**Technical Review: Inadvertent Intrusion Analysis for the
U.S. Department of Energy 2020 Performance Assessment for the
Saltstone Disposal Facility at the Savannah River Site**

April 18, 2023

Christianne Ridge, Sr. Risk Analyst, U.S. Nuclear Regulatory Commission

Figure 1. NRC staff overlay of DOE modeled intrusion well locations and DOE stream traces (adapted from Figures 4.4-115 and 6.1-1 in the 2020 SDF PA)

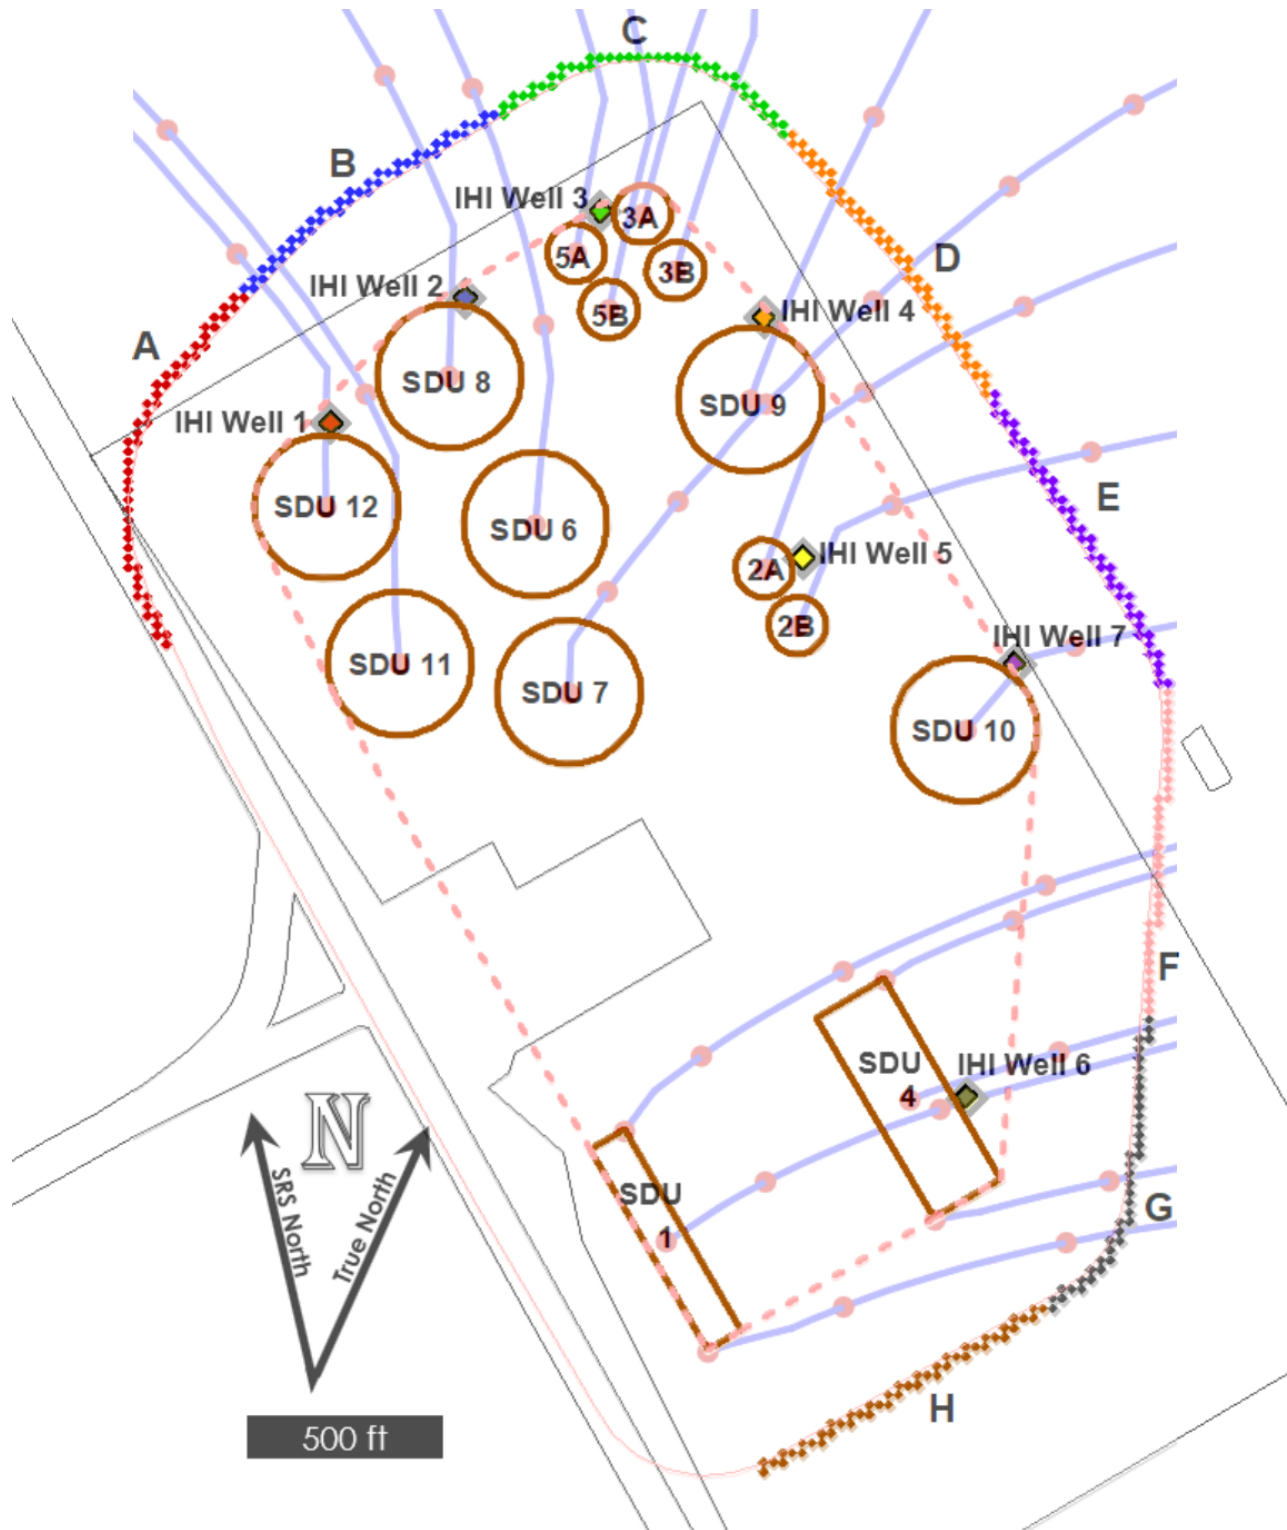
The main difference between the groundwater radionuclide concentrations the DOE used for an inadvertent intruder and a member of the public was the modeled well locations. For a member of the public, the DOE modeled the radionuclide concentration at locations 100 m (328 ft) from the SDF boundary. For an inadvertent intruder, the DOE selected the location with the greatest radionuclide concentrations along the 1-m boundary in addition to seven locations within the boundary of the SDF that the DOE labeled as Inadvertent Human Intruder (IHI) wells (see Figure 1, below). The DOE assessed the point of maximum radionuclide concentration along the 1-m boundary each year, so that the location of the well always reflected the point of maximum concentration. In addition, the DOE chose the maximum concentration of each radionuclide irrespective of depth. Table 2 in this TRR provides the DOE basis for each intruder well location. The DOE determined that the projected dose at the point of maximum radionuclide concentration along the 1-m boundary was greater than the projected dose at any of the seven intruder wells.

Figure 4. Projected dose from chronic exposure to soil drill cuttings and contaminated groundwater at the SDF (Figure IHI-3.2 in SRR-CWDA-2021-00047, Rev. 1)

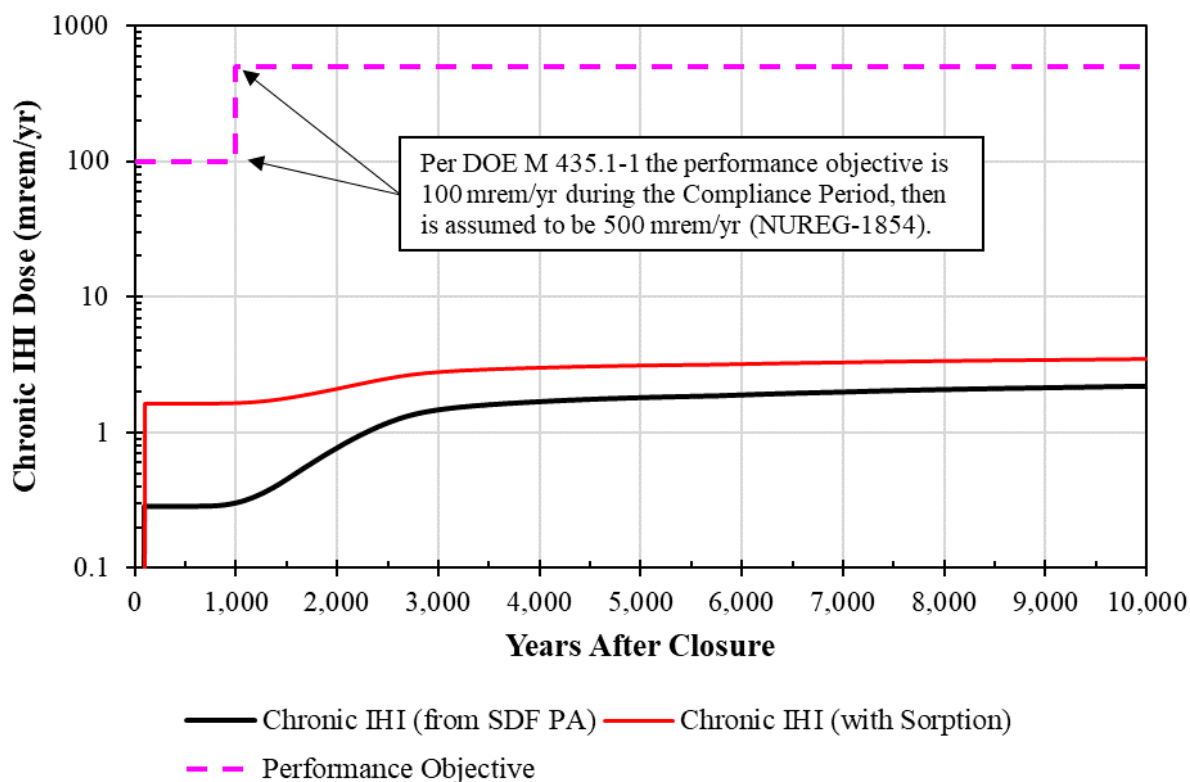
Figure 4, below, shows the projected dose to a chronically exposed individual in a soil-drilling scenario for both the original calculation in the 2020 SDF PA and the DOE revised inventory to account for sorption (SRR-CWDA-2021-00047, Rev. 1). As shown in Figure 4, the DOE RAI response provided slightly greater projected doses than the original analysis in the 2020 SDF PA. However, the projected doses were well below the 5 mSv/yr (500 mrem/yr) dose constraint the NRC uses to evaluate compliance with the 10 CFR 61.42 PO for an inadvertent intruder. Figure 4 also shows a 1 mSv/yr (100 mrem/yr) performance objective for the first 100 years after SDF closure. That performance objective is based on DOE M 435.1 and does not reflect an NRC performance objective.

Although the DOE did not provide dominant radionuclides or pathways for the revised dose projection in the DOE response, the model files provided with the DOE response indicated that plant ingestion contributed most to the projected dose within 2,000 years of site closure, and water ingestion contributed most to the projected dose between 2,000 and 10,000 years after SDF closure. The DOE model output also showed that Tc-99 made the greatest contribution to the projected dose within 10,000 years of site closure (73 percent), followed by I-129 (28 percent). No other radionuclides contributed significantly to the projected dose from acute exposure for an individual drilling near a disposal structure.

Figure 8. Central Scenario Dose Projections for Chronic Exposure in a Soil-Drilling Scenario (Figure 6.7-3 in the 2020 SDF PA)

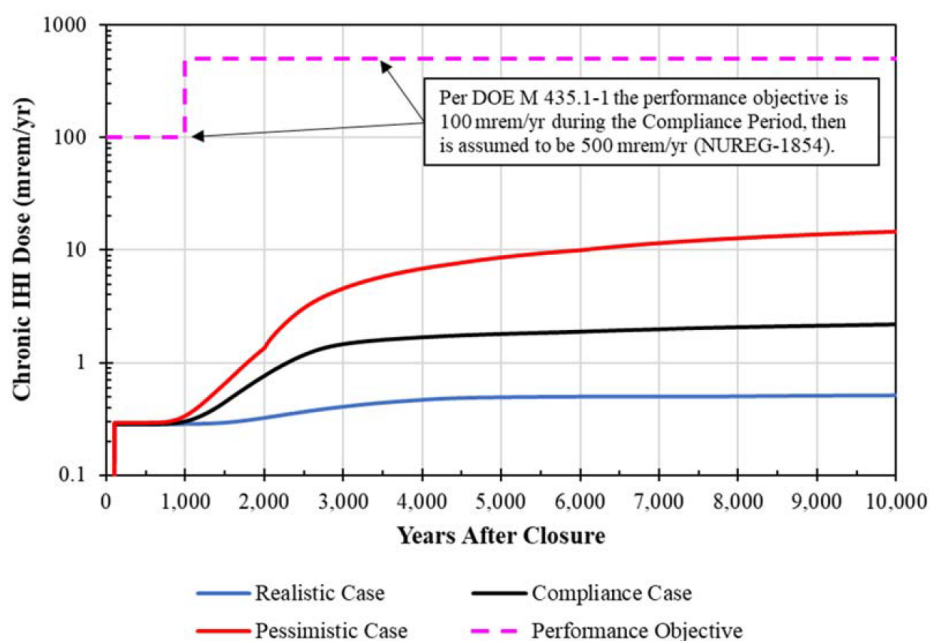
Figure 8 shows a factor of 29 difference between the Realistic and Pessimistic Case peak projected dose within 10,000 years of site closure for a chronically exposed inadvertent intruder in the soil-drilling scenario (i.e., 0.0051 mSv/yr [0.51 mrem/yr] versus 0.15 mSv/yr [15 mrem/yr]). Those numerical results correspond to the soil drill cuttings inventory before the revision to account for soil sorption, which increased the projected dose to a chronically exposed inadvertent intruder by approximately 50 percent in the Compliance Case (see Figure 4).

Figure 9. PRCCs for the Projected Dose from Chronic Exposure in a Soil-Drilling Scenario at the 1-m SDF boundary (Figure 6.6-6 in the 2020 SDF PA)

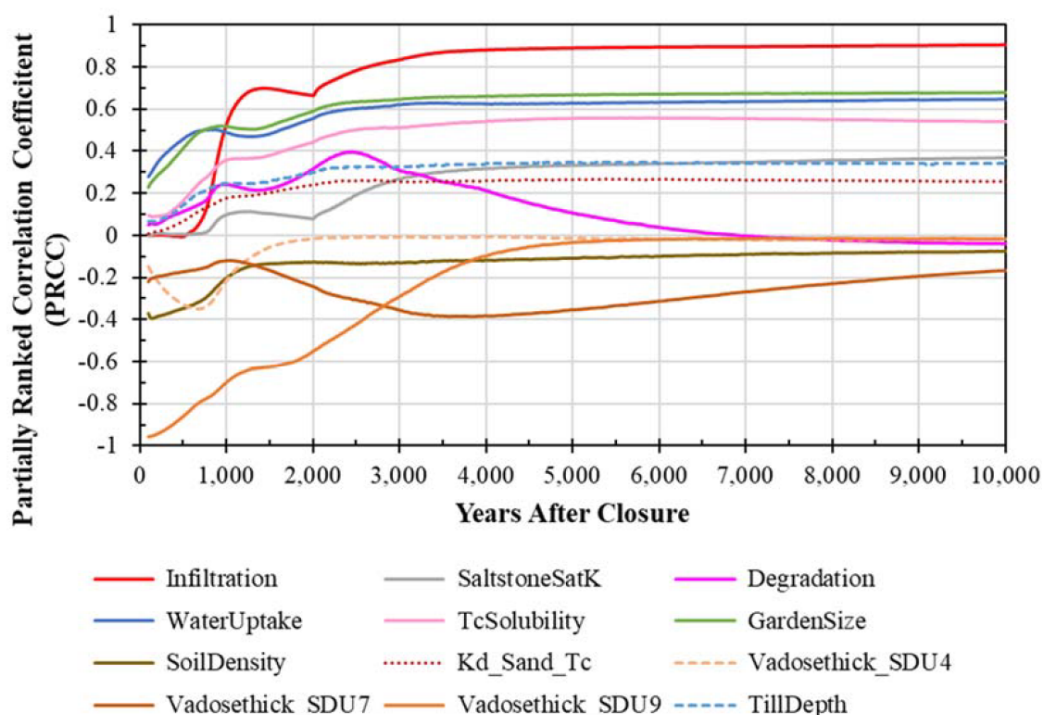
Figure 9 shows the PRCC for the variables with the top 12 absolute magnitudes during the 10,000 years after site closure, based on the projected dose to a chronically exposed inadvertent intruder along the 1-m SDF boundary. Comparison of Figure 9, below, with Figure 5.7-10 in the 2020 SDF PA shows that the results for a chronically exposed inadvertent intruder at the 1-m SDF boundary are very similar to the results for an offsite member of the public. Specifically, nine of the top twelve PRCCs for the chronically exposed inadvertent intruder were also in the top 12 PRCCs for an offsite member of the public. In addition, the parameter with the largest positive correlation to the projected dose for most of the 10,000 years after SDF closure for both analyses was the infiltration and the parameter with the largest negative correlation to the projected dose for the first several hundred years after site closure for both analyses was the thickness of the vadose zone under SDS 9. Of the variables that differed, the vadose zone thickness for SDS 4, vadose zone thickness for SDS 7, and sorption coefficient (referred to as a “ K_d ” in Figure 9 in this TRR) for Tc in sand were more important for a chronically exposed inadvertent intruder. The leachate-impacted sorption coefficient for iodine in

sand, unimpacted sorption coefficient for iodine in sand, and saturated width under SDS 7 were more important for an offsite member of the public.

Figure 10. Diagram of a well bore intersecting a transfer line of equal radius (created by NRC staff with Microsoft Paint-3D software)

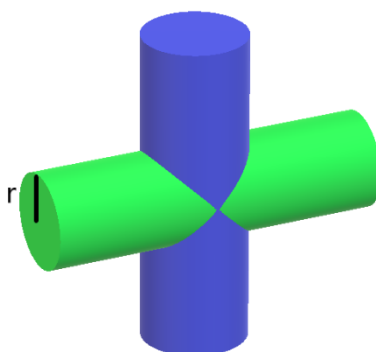
Based on Equation 3, the volume of grout in an abandoned transfer line on the SDF that could be intersected by a well if the well and transfer line both had a diameter of 30.5 cm (12 in) is 0.018 m³ (1,100 in³). That volume is smaller than the grout volumes the DOE assumed an intruder could be exposed to in the grout-drilling scenarios, which range from 0.050 m³ (1.8 ft³) to 0.10 m³ (3.5 ft³) (see Table 4 in this TRR). Therefore, the NRC staff determined that the acute and chronic grout-drilling scenarios the DOE evaluated bound the results from drilling through a transfer line filled with grout. Decontaminated salt waste has slightly greater radionuclide concentrations than saltstone grout because the decontaminated salt waste is only one component of the grout. The 2020 SDF PA does not indicate the exact volumetric fraction of grout that is composed of decontaminated salt solution. However, the fraction can be estimated from the mass-based water-to-cement ratio of approximately 0.60 specified in the 2020 SDF PA. If approximately 40 percent of the volume of saltstone is premix and 60 percent is salt waste, the radionuclides in the decontaminated salt waste would have concentrations approximately 1.7 times greater than the radionuclides in the grout. Because the grout volumes the DOE modeled in the grout-drilling scenarios is more than a factor of two greater than the estimated volume of cuttings from drilling through a transfer line, the NRC staff determined that the grout-drilling scenario would bound the results from drilling through a transfer line filled with decontaminated salt waste.

Figure 11. NRC Staff Overlay of the DOE Modeled Numerical Grid and Concentration Gradient of a Conservative Tracer in SDS 9 (Adapted From Figures 4.4-114 And 4.4-127 of the 2020 SDF PA)

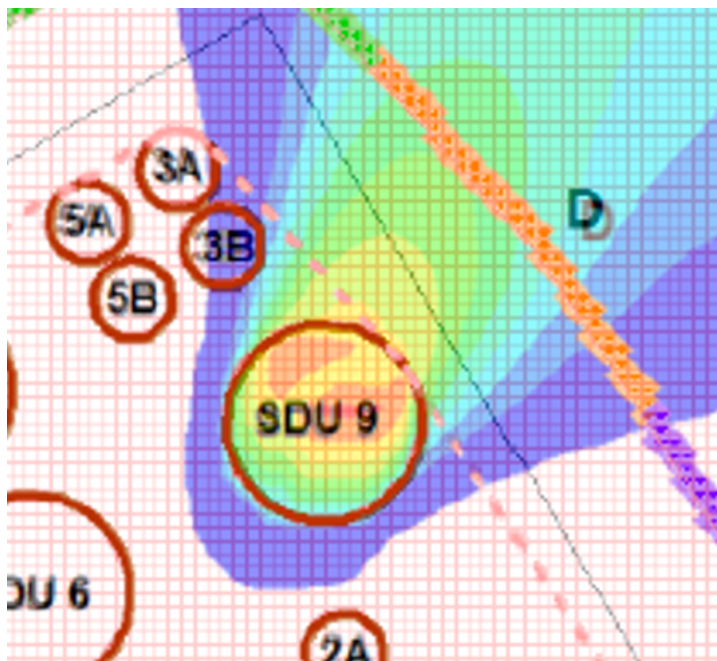
In this review of the 2020 SDF PA, the NRC staff found the DOE use of the radionuclide concentrations in the PORFLOW grid cells that touch the 1-m boundary to be acceptable for three reasons. First, in the 2020 SDF PA, the DOE reduced the grid size to one fourth the area of the grid size the DOE used in the 2009 SDF PA (i.e., vs. 58 m² [625 ft²] vs. 232 m² [2500 ft²]). Reducing the grid size would reduce the numerical effect of averaging concentrations over a grid cell. Second, Figure 11, below, shows that the concentration of a non-sorbing tracer does not change much over the scale of the numerical grid. That gradual change implies that the grid is fine enough that the average concentration of a mobile radionuclide like I-129 or Tc-99 in a grid cell at the edge of the SDF adequately represents the concentration at the 1-m boundary. Third, the NRC staff expects that some amount of averaging is realistic because a well at the 1-m boundary would draw in water from a region around the well (i.e., the area of effect), which would physically mix water with higher and lower radionuclide concentrations. For slower, shorter-lived radionuclides, the NRC staff expects the concentration gradient to be greater than shown in Figure 11. However, for those radionuclides the NRC staff expects the smaller grid size and real physical averaging in the well area of effect will mitigate any artificial dilution caused by averaging over the grid cells.

Figure 12. Function Representing Chronic Inhalation of Suspended Garden Soil in the DOE Model *SRS Saltstone V5.051_PF_Casecv.8_SL_Ratio_IHI_SDU7_Drill*

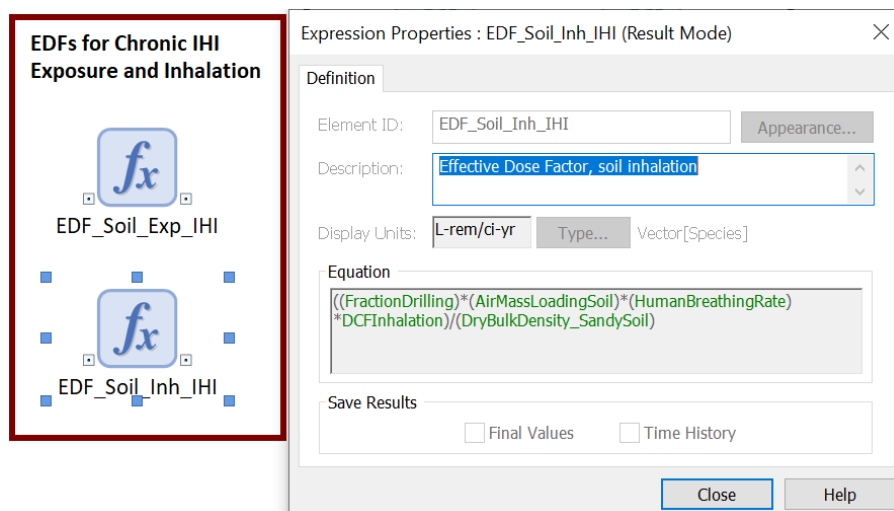
First, in the 2020 SDF PA, the DOE indicated that it intended to model inhalation and direct exposure of an inadvertent intruder to radionuclides in garden soil for the modeled gardening time. However, in the implementation of the Dose and Exposure Pathways Model for the chronically exposed inadvertent intruder, the DOE used the parameter "FractionDrilling" for the dose contribution from inhaling suspended soil contaminated by mixing with drill cuttings (see Figure 12 below) for the chronically exposed inadvertent intruder. The NRC staff expected that parameter to be "FractionInGarden," to reflect that a chronically exposed inadvertent intruder could inhale suspended soil during the time gardening. Because the deterministic value of the fraction of the year gardening is significantly greater than the deterministic value of the fraction of the year drilling (i.e., 1,900 h/yr versus 20 h/yr), using the fraction of the time gardening would increase the projected dose to a chronically exposed inadvertent intruder.

To assess the risk significance of using the fraction of time gardening instead of the fraction of time drilling, the NRC staff used the intrusion models the DOE provided with the DOE document SRR-CWDA-2021-00047, Rev. 1, to conduct an independent analysis. The NRC staff found that changing the input for the exposure time for inhalation had an insignificant effect on the projected peak dose to a chronically exposed inadvertent intruder in the grout-drilling scenario (i.e., it increased the peak projected dose from 1.70 mSv/yr [170 mrem/yr] to 1.72 mSv/yr [172 mrem/yr]). The change had a minimal effect on dose because plant ingestion dominated exposures for a chronically exposed inadvertent intruder (i.e., 87 percent of the projected peak dose), followed by inadvertent soil ingestion (i.e., 6.6 percent of the projected dose). Therefore, although increasing the exposure time increased the dose contribution from inhalation of suspended soil by approximately a factor of 10, it had a minimal effect on the total projected peak dose.
